Subject **Response to Comments – Preliminary Traffic Impact and Assessment – Jimmy John’s Sandwich Shop, 295 Westport Avenue, Norwalk, Connecticut**

We are pleased to provide a response to a memorandum prepared by the City Director of Transportation, Mobility and Parking dated June 23, 2021 for the proposed Jimmy John’s Sandwich Shop to be located at 295 Westport Avenue.

EXHIBIT A

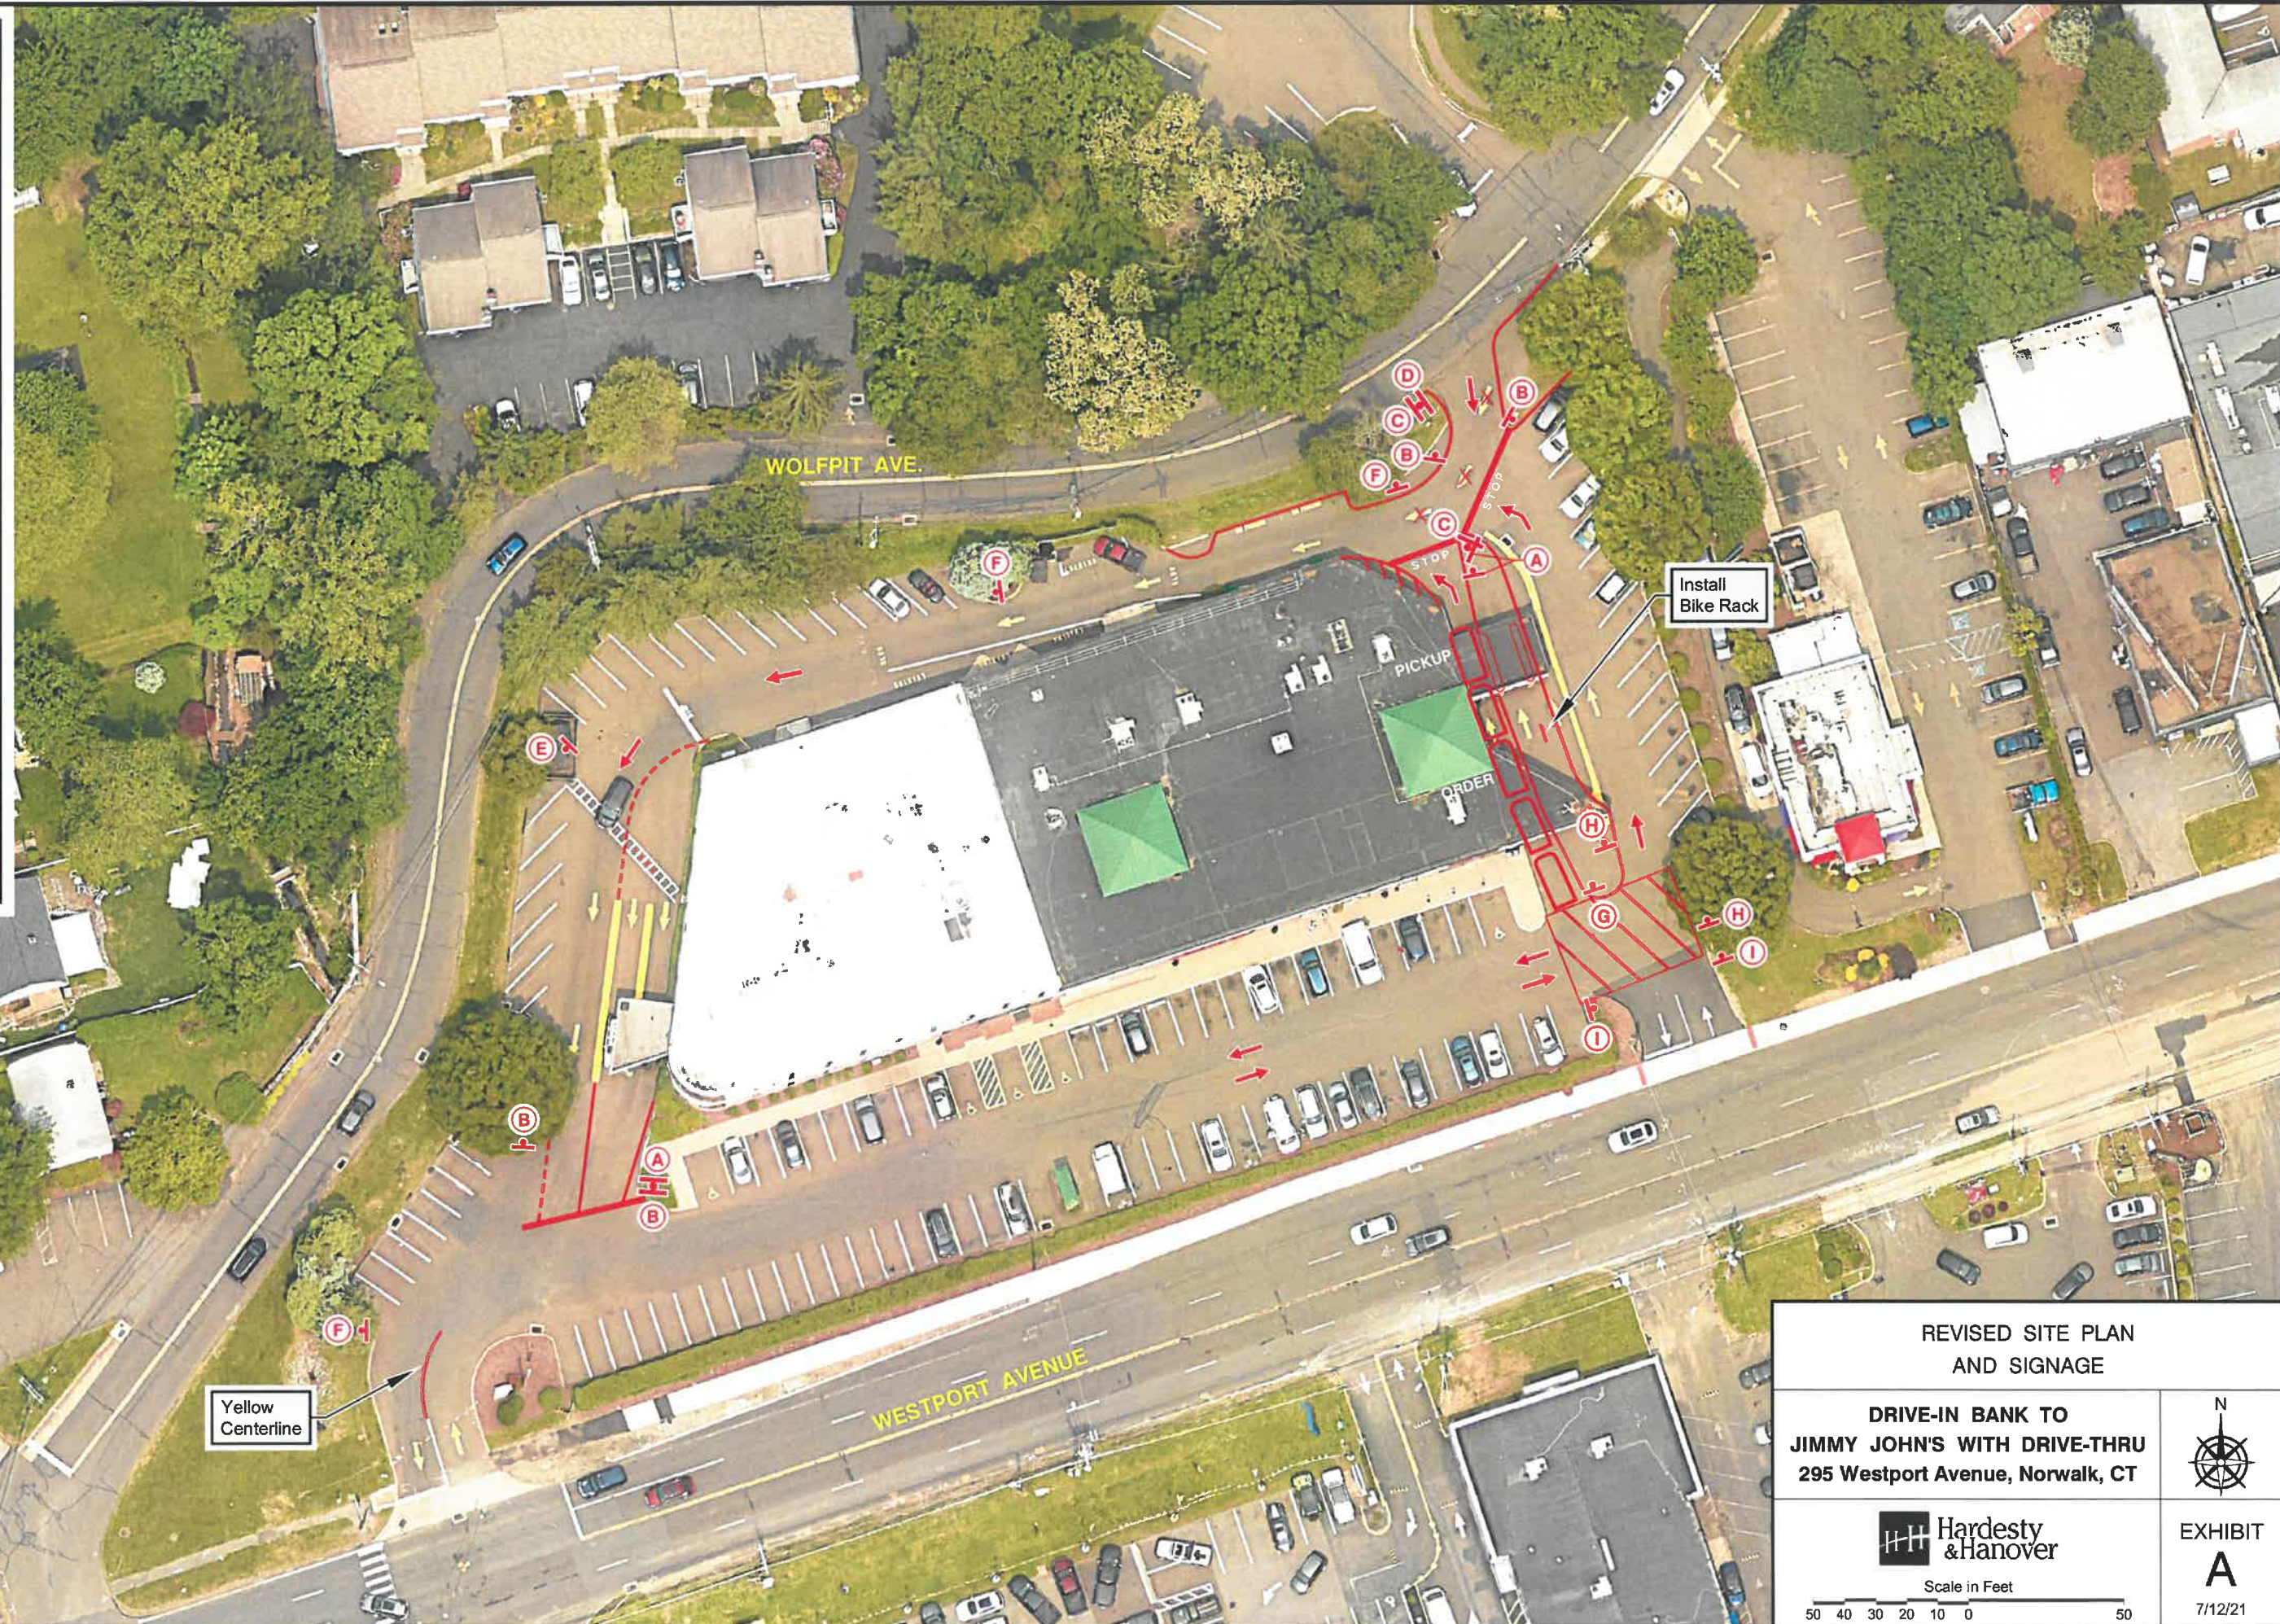
1. *Comment A (Operations)* -- *It is our understanding that the proposed Jimmy John’s will accommodate several functions including a drive-thru, short-term pick-up and a walk-up window. As there are many other uses on Site which share the parking lot and are dependent on the existing counter-clockwise traffic circulation around the building, Jimmy John’s proposed operations have the potential to adversely impact Site traffic circulation.*

9. *Comment 1F – The Revised Site Plan should include all relevant traffic control, parking, and wayfinding signage on the proposed to ensure orderly and efficient traffic flow on-site.*

11. *Comment 1H – It is indicated that the Application no longer includes the conversion of the access drive on Wolfpit Avenue and that it will remain one-way as it exists today. The Application should provide a vehicle turning template for this driveway and its current configuration should be reviewed*

(width of the curb cut reduced as necessary) to prevent it from informally being utilized as a two-way driveway and also reduce the speeds of vehicles entering the site. All relevant signage and pavement markings should be updated to re-enforce this one-way operation.

Response A (Operations) - The proposed operations have been simplified to mitigate concerns about site traffic. The walk-up window and proposed six short-term parking spaces have been eliminated. At the site, Jimmy John’s customers can either park and walk in or use the drive-thru lane. Customers can place orders in the following ways: in store; by phone or online for in-store pickup; at the drive-thru; and by phone or online for delivery.

Please see the revised site plan attached as “Exhibit A – Revised Site Plan and Signage”.

Response 1B – As noted above in “Response A (Operations)”, the curbside pick-up and the related proposed parking spaces have been removed, which eliminates the need to create a pedestrian connection immediately adjacent to the drive-thru lane. The updated site plan, which is attached as “Exhibit A – Revised Site Plan and Signage”, shows the elimination of these six parking spaces and the two drive-thru lanes, which previously accommodated the bank use of the building. Separation between the parking aisle and the drive-thru lane can be either a painted flush island or, if determined appropriate by the City, a raised asphalt island. However, it is our opinion that the painted flush island is sufficient since there will no longer be vehicles parking immediately adjacent to the drive-thru window and there is no longer a need to physically separate the two. Further, a bike rack is now proposed in this location.

Response 1F – Refer to the attached “Exhibit A – Revised Site Plan and Signage” which conceptually shows traffic control signing and pavement markings throughout the site, including way finding-type signage to further support the existing ONE-WAY, counterclockwise circulation pattern at the Shopping Center, which has been in place for many years. It has been found that this circulation pattern, with two drive-thru uses on either end of the existing building operated without any difficulty, traffic delays or pedestrian conflicts. The proposed pavement marking and signing plan only support and improve the circulation and clarity of the counterclockwise, one-way format as noted above. There is a continuous one-lane aisle on each of the building, except the front of the building, which is a two-way aisle and will remain as a two-way aisle format.

Response 1H – The attached updated plan indicates the section of pavement area in the rear access drive from Wolfpit Avenue into the Shopping Center to be removed. In addition to reducing the amount of pavement and modifying the radii on either side of the driveway along Wolfpit Avenue, appropriate traffic control signing is now included to better define this access drive as entrance only and restricting all exiting movements from the Shopping Center to Wolfpit Avenue. This should address the concern that this driveway has been functioning as a two-lane, two-way access drive in the past.

Response 1J – Refer to the Updated Site Plan, which shows the location of a bike rack in the area of the previously located drive-thru lanes for the former bank use.

However, we offer additional pavement markings and signing, which is provided in the attached "Exhibit A – Revised Site Plan and Signage". Specific information for the drive-thru lane is provided in the attached "Exhibit B – Layout and Drive-Thru".

Exhibit B

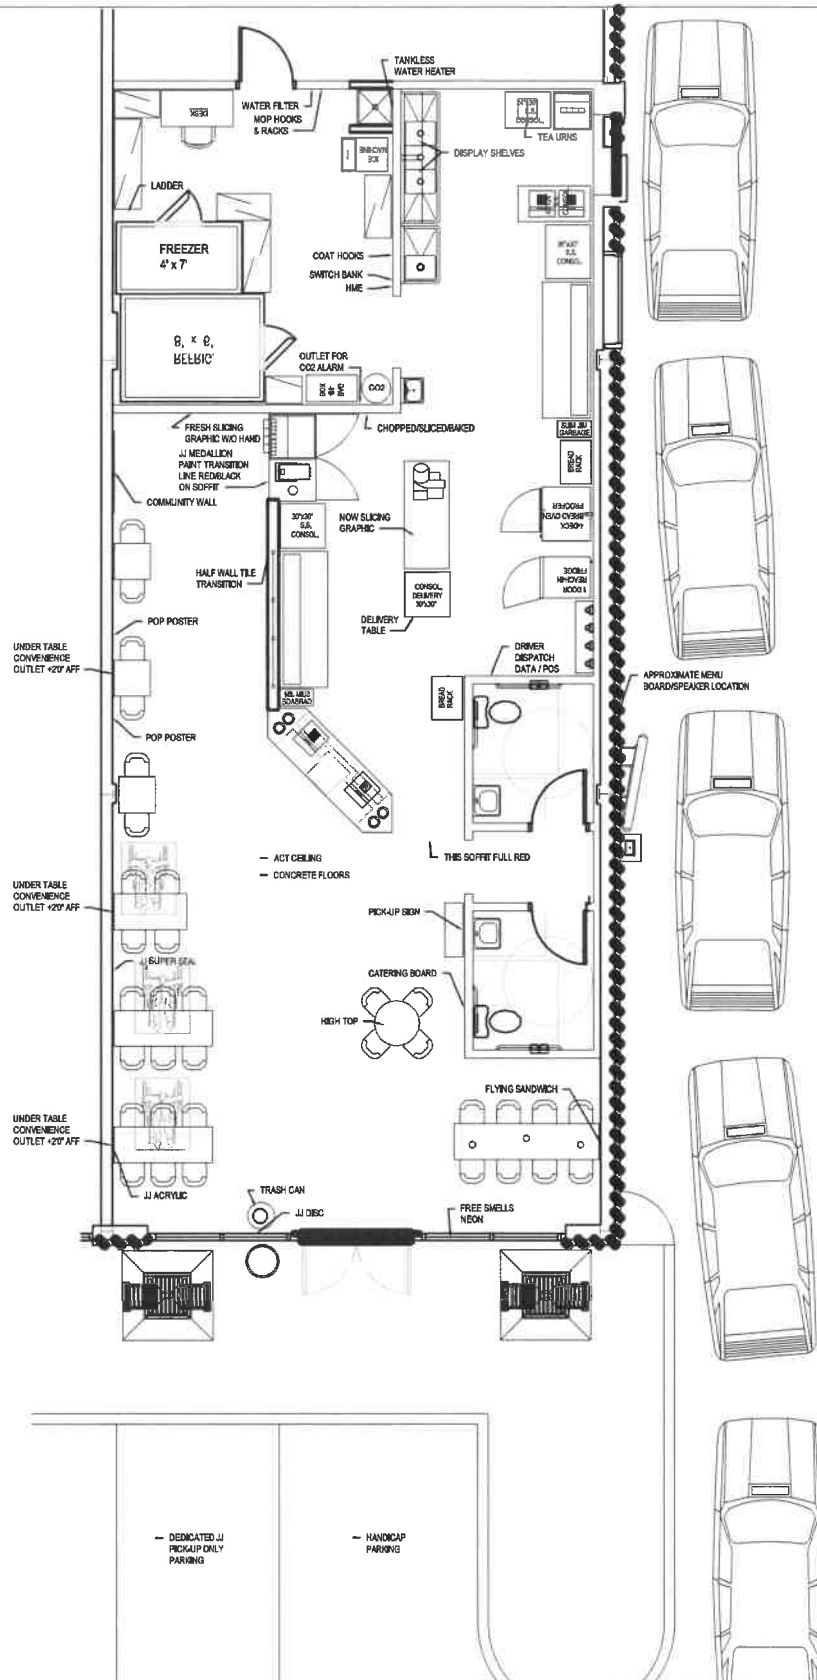
3. Comment C (Revised Site Plan and Traffic Flow) – Additionally, the revised Site Plan should clearly identify how all of Jimmy John’s proposed activities will take place given the small footprint of the building/Site. While Andriopoulos Design Associates submitted a “Tenant Drive-Thru Concept #1” as part of Hardesty & Hanover’s response to TMP comments, it does not address how the drive-thru, short-term pick-up, walk-up window will interact and not adversely impact the counter-clockwise circulation around the Site which is also utilized by the other businesses and critical to their operations. It is critical that proposed uses operations do not adversely impact traffic circulation within the Site as it could have negative impacts on Westport Avenue.

Response C (Revised Site Plan) – Please see “Response A (Operations)” and please note that “Exhibit A – Revised Site Plan and Signage” and “Exhibit B – Layout and Drive-Thru” should be referred to as the most up-to-date proposals.

Exhibit D

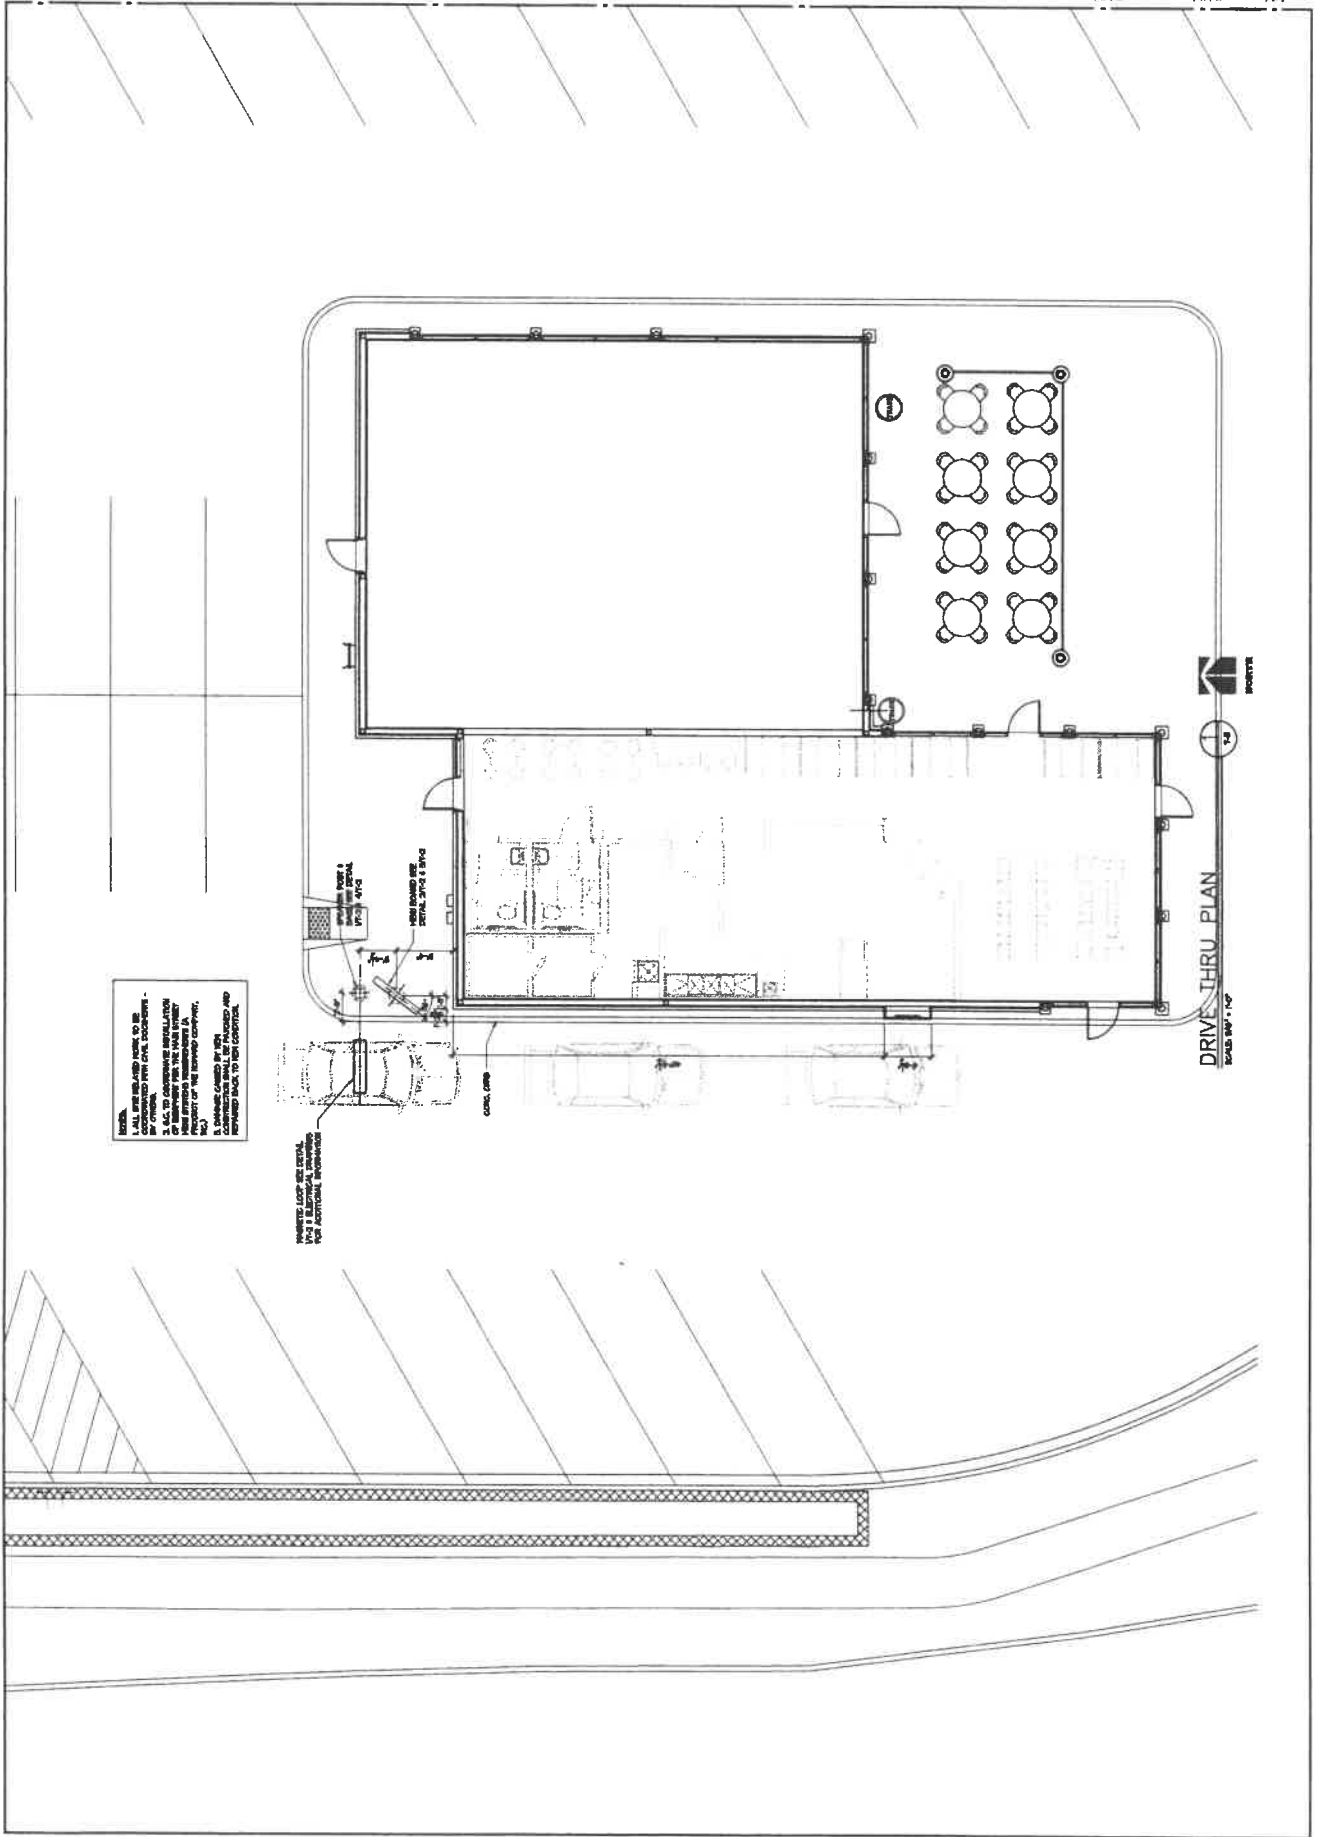
2. *Comment B (Queuing)* – *While it was indicated that up to five (5) vehicles can queue from the pick-up window to the end of parking along the building frontage; it should be noted that the queuing lane can only accommodate up to three (3) vehicles from the menu board/speaker location before traffic flow within the Site is adversely impacted.*

A preliminary review of other existing Jimmy John's drive-thru's in New York suggests much more significant queuing lanes are necessary to accommodate operations. For example, one Jimmy John's reviewed had up to 130 feet between its pick-up window and menu board/speaker location and did not share a parking lot with any other uses. Another Jimmy John's drive-thru provided approximately 60 feet between its pick-up window and menu board/speaker board location and another 65 feet to accommodate queuing before adversely impacting site traffic circulation. A final location reviewed, appeared to have 65 feet between its pick-up window and the menu board/speaker location and another 55 feet to accommodate queuing before adversely impacting site traffic circulation. Based on a review of this application, the approximate queuing lane for this Site is significantly less than similar developments. TMP remains concerned that drive-thru queuing could adversely impact site traffic circulation and ultimately traffic operations on Westport Avenue. The Applicant should provide mitigation through a revised Site Plan as further outlined in this memorandum.

Sample store layouts received from Jimmy John's staff are attached as "Exhibit C – Drive Thru Example #1" and "Exhibit D – Drive Thru Example #2". Exhibit C is a store just built last year that reflects this new drive-thru setup. Exhibit D is one of Jimmy John's highest volume stores, which has had no issues with this setup.
